**Meeting of the Central Valley Flood Protection Board  
January 23, 2015**

**Staff Report**

**Union Pacific Railroad Bridge (No. 143.71) Replacement, Sutter County**

**Table 2: Proposed 8-span, 240' long Concrete Bridge**

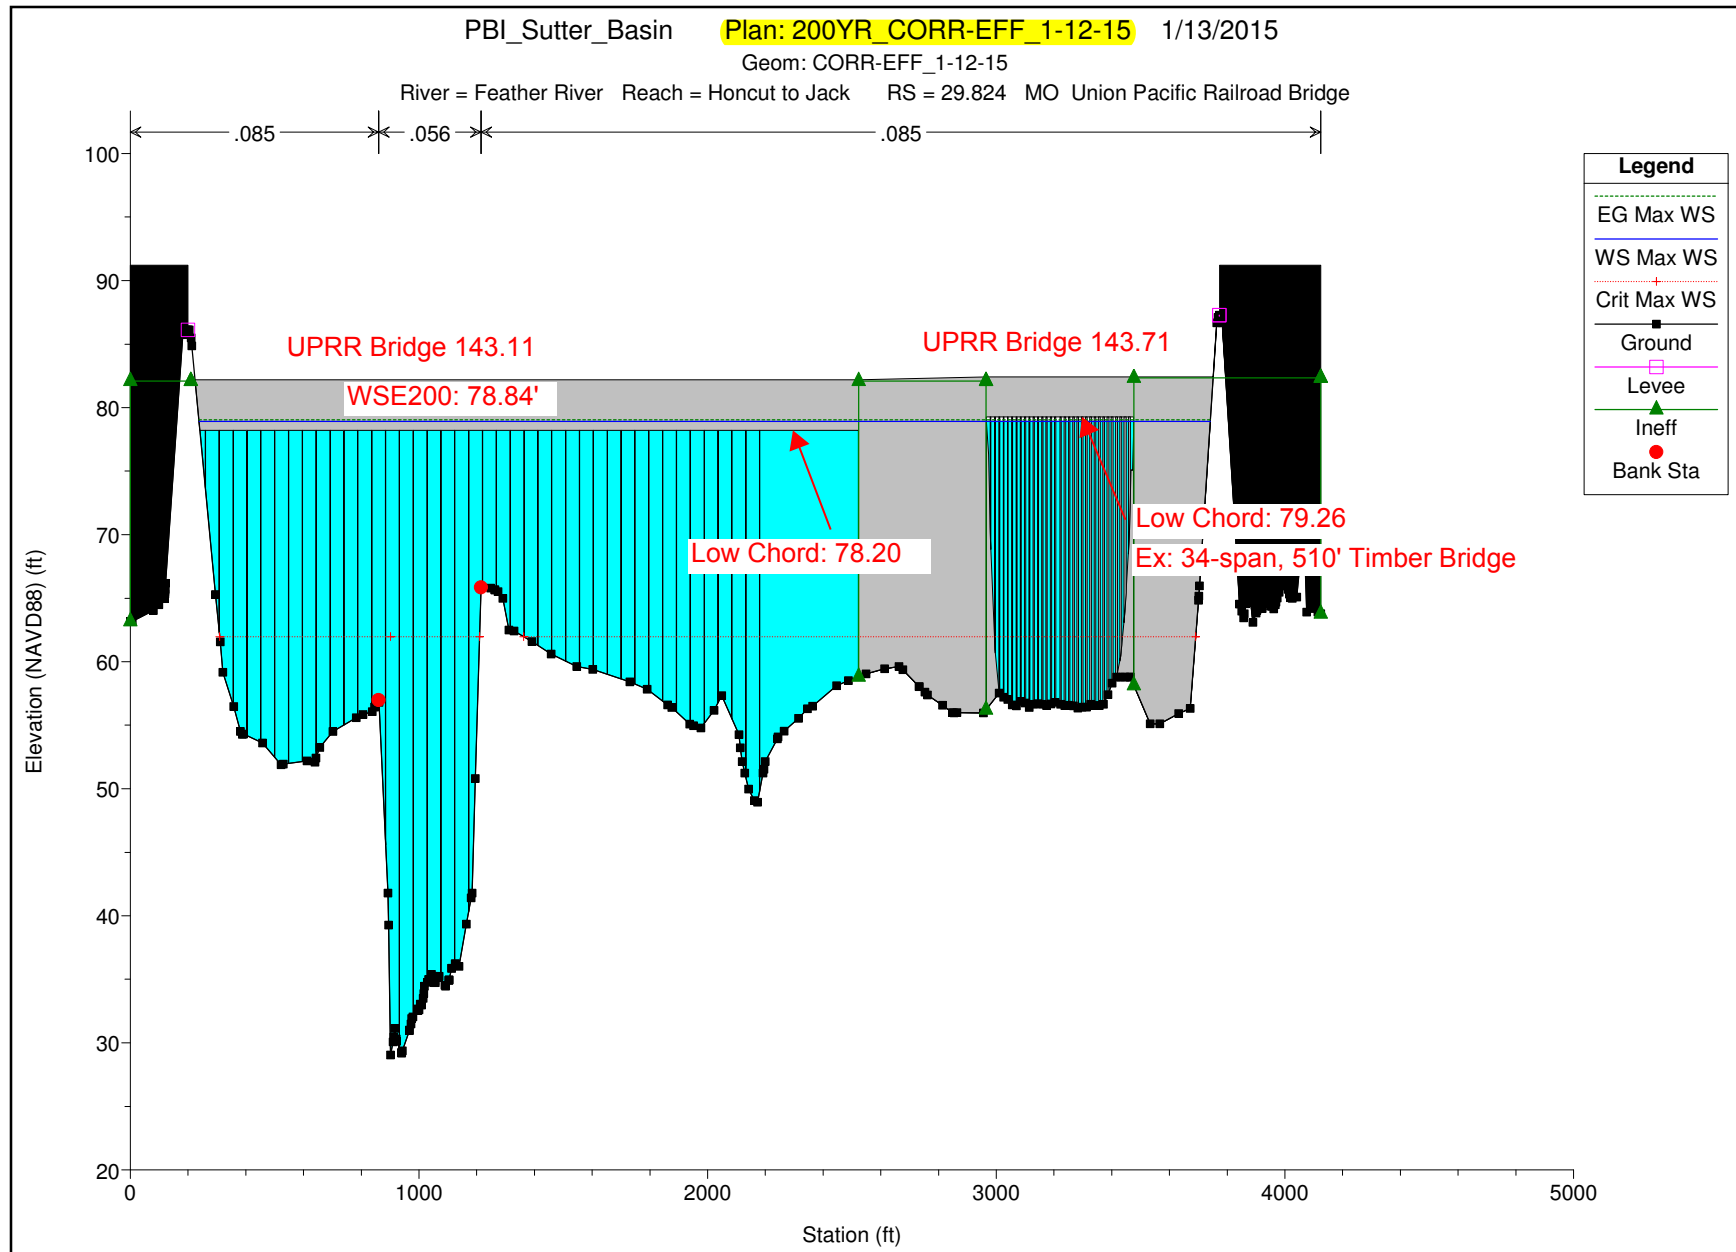
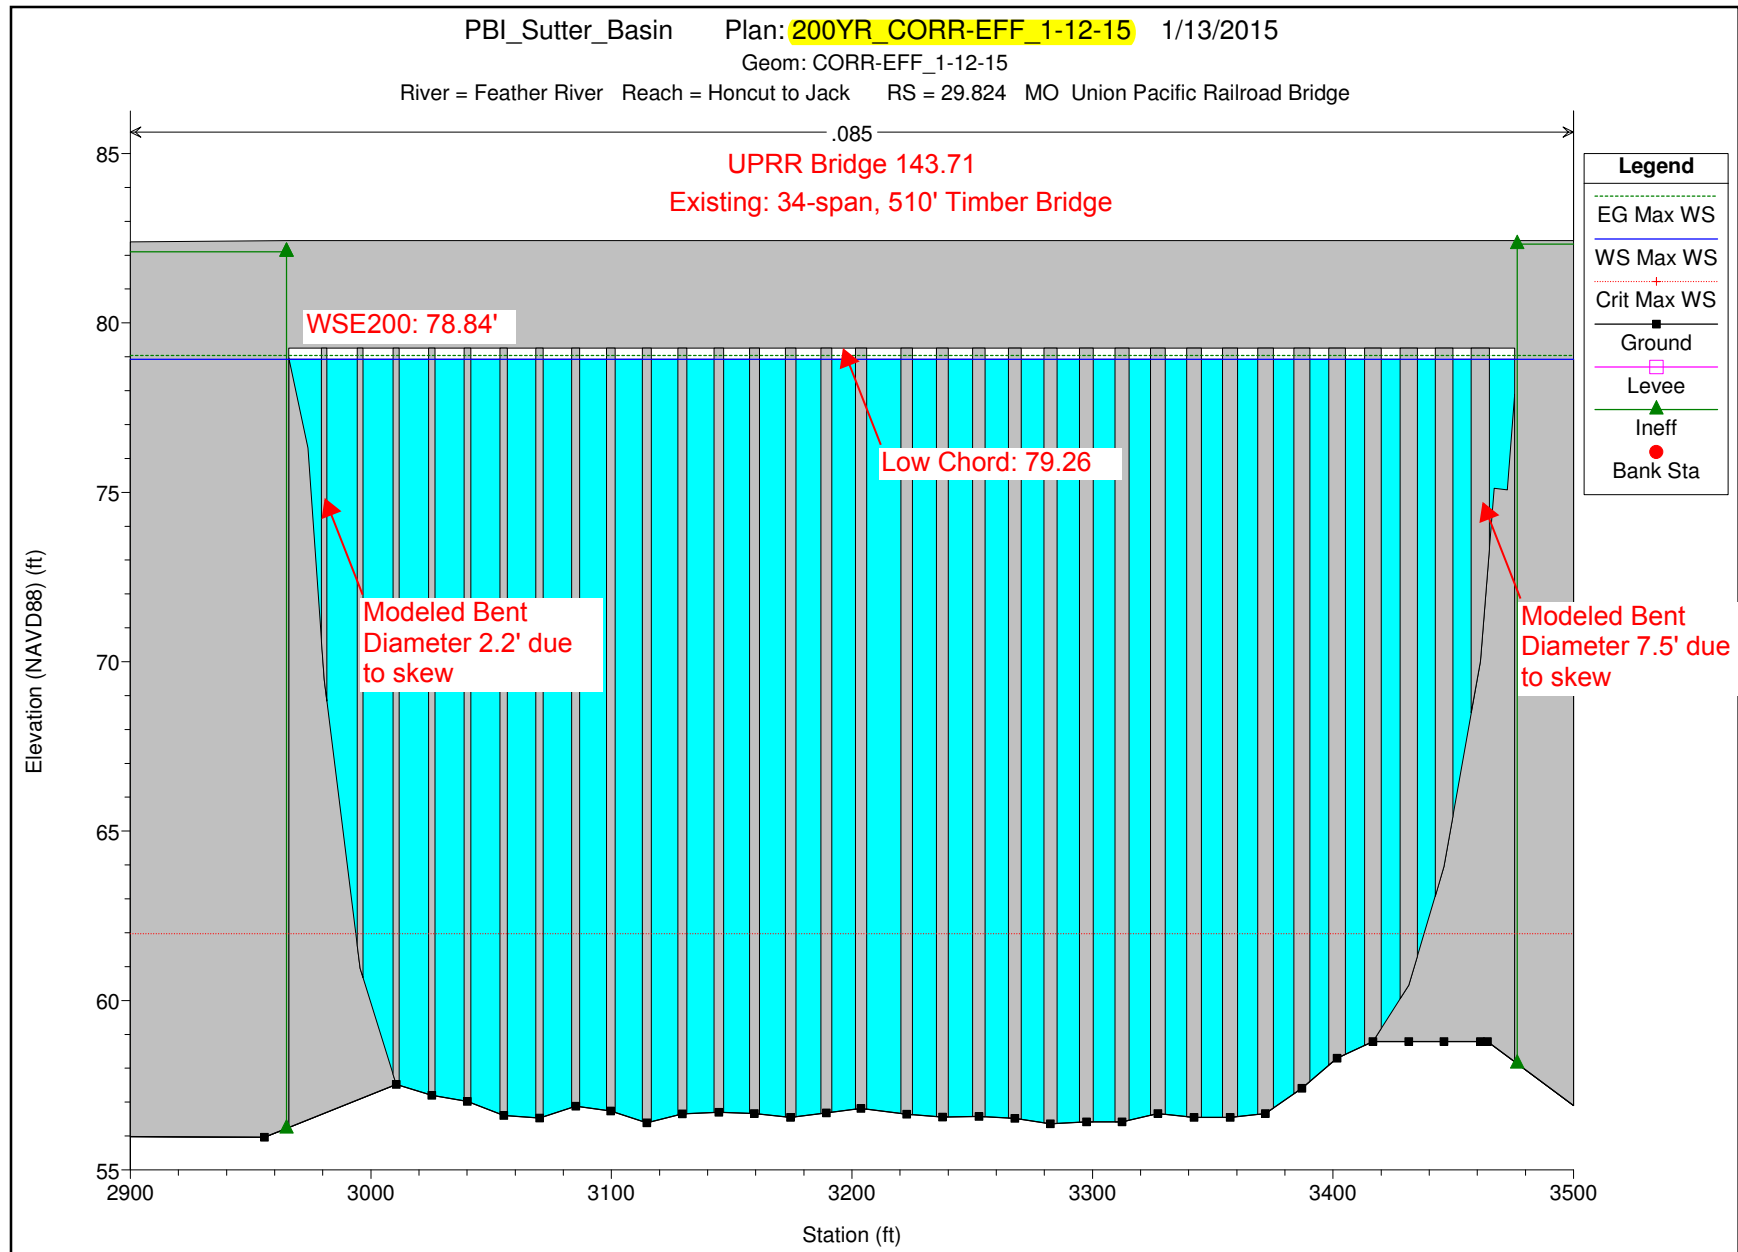
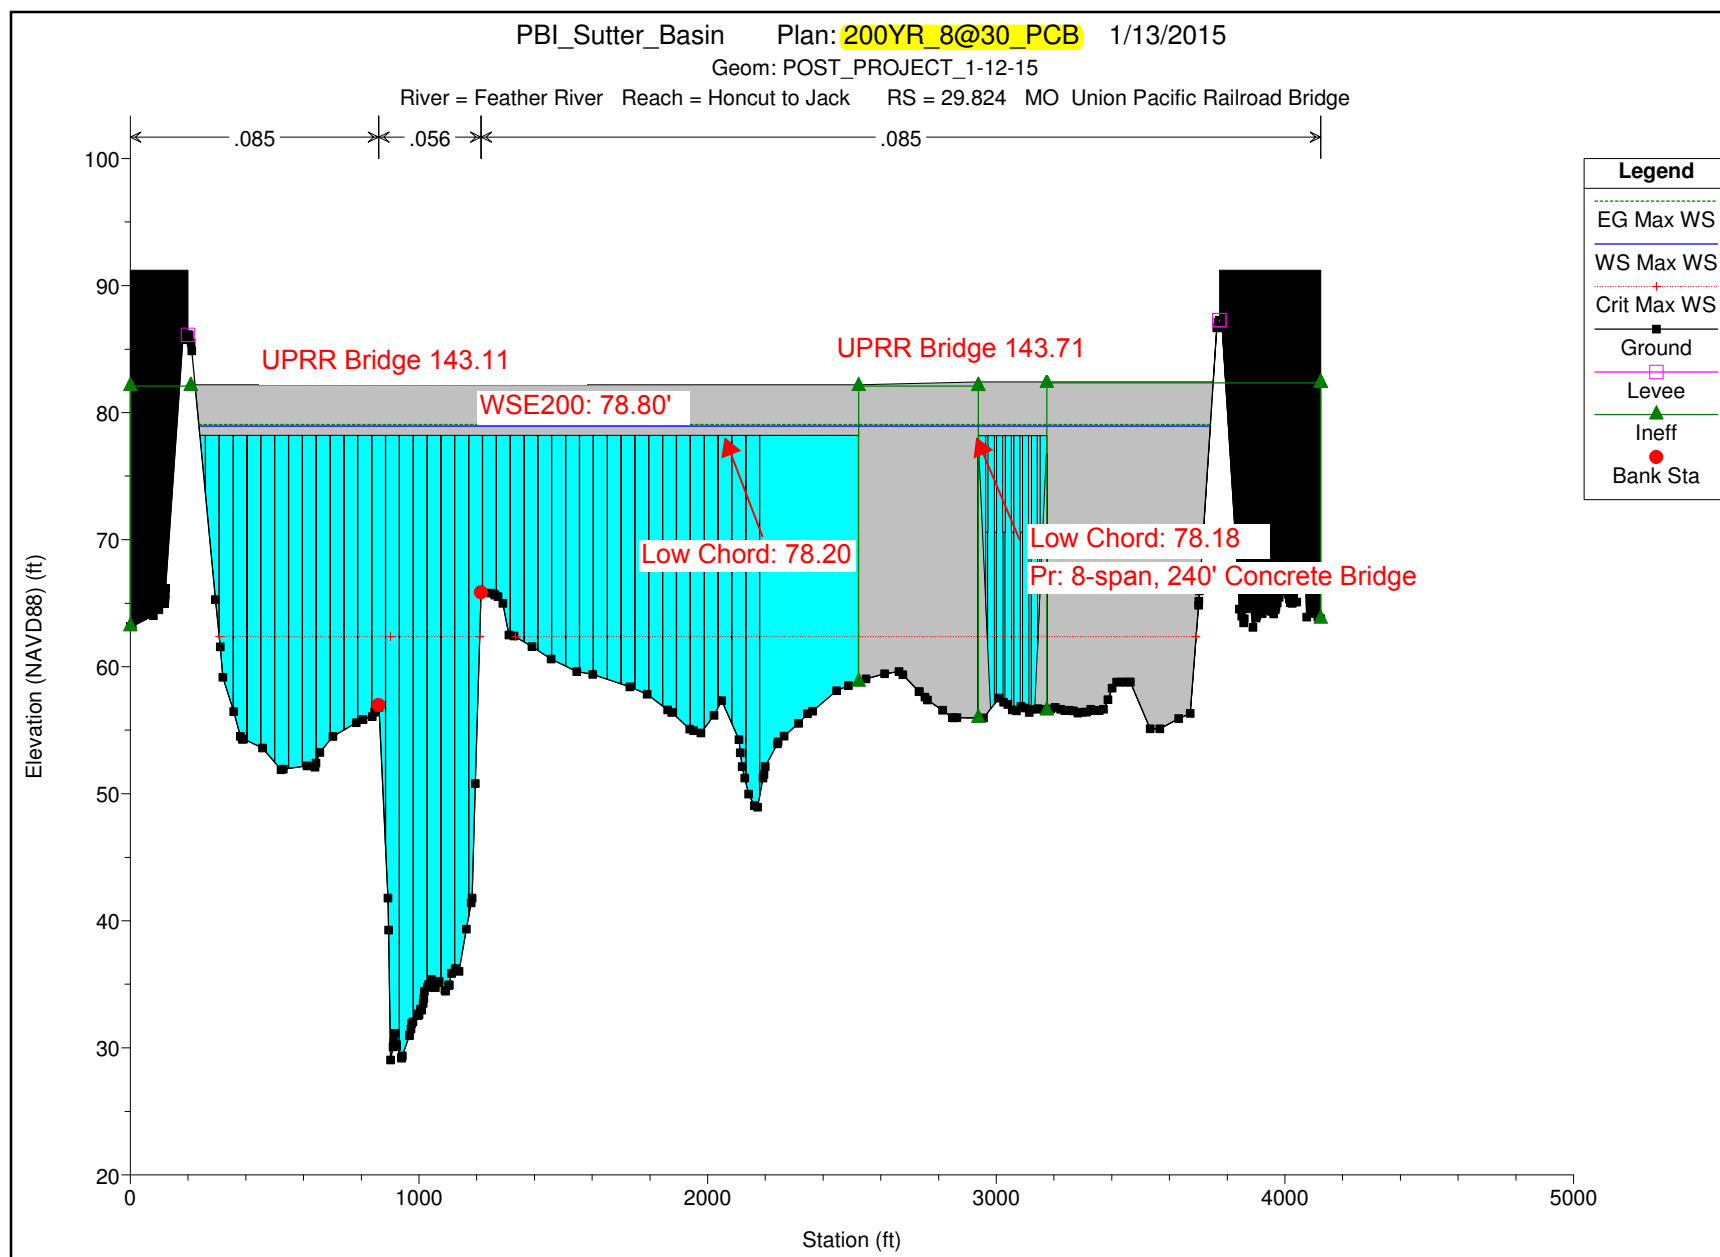
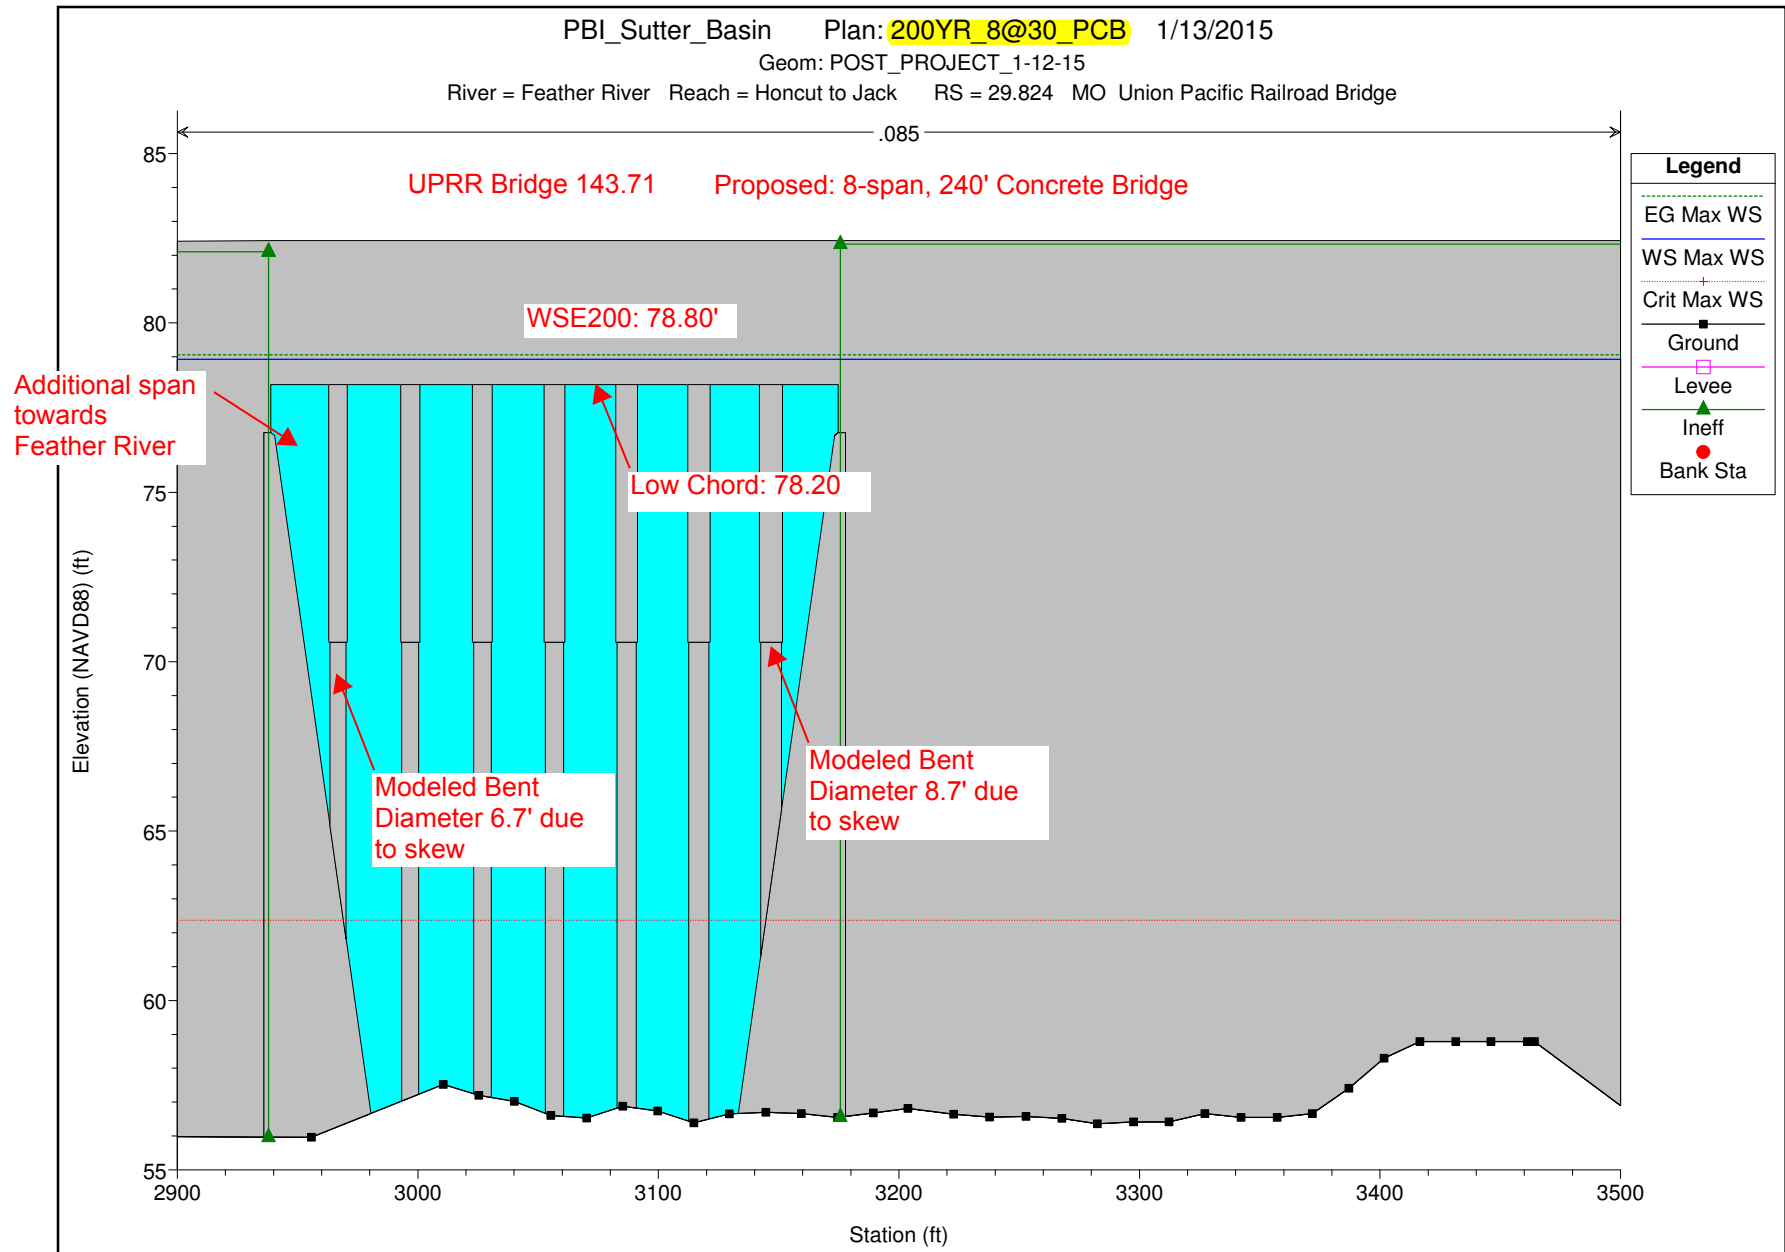
The 200-year WSE at the upstream and downstream faces of the proposed bridge was initially computed to be 78.78 feet for both pre- and post-project conditions (Attachment G). In response to concerns raised by LD1 regarding model design, UPRR revised the hydraulic model to remove ineffective flow areas in the floodway. The revised model

resulted in minor changes to the WSE profile with a computed decrease of 0.03 feet at the downstream bridge face, and a maximum increase of 0.04 feet just upstream of the bridge.

LD1's conditional approval (see Section 6.0) requested the UPRR to modify its bridge design in order to achieve zero computed WSE increase. In response to this request UPRR modified its design by adding one additional span at the southeastern end of the concrete bridge section. This modification replaces a portion of the existing railroad embankment currently blocking the floodway with an additional 30-foot width of open bridge to convey flood flows. The increased floodway conveyance offsets all prior computed increases in WSE based on the initial bridge design, and satisfies the requirements of LD1's endorsement Condition No. 8 that the new bridge result in no WSE increase.
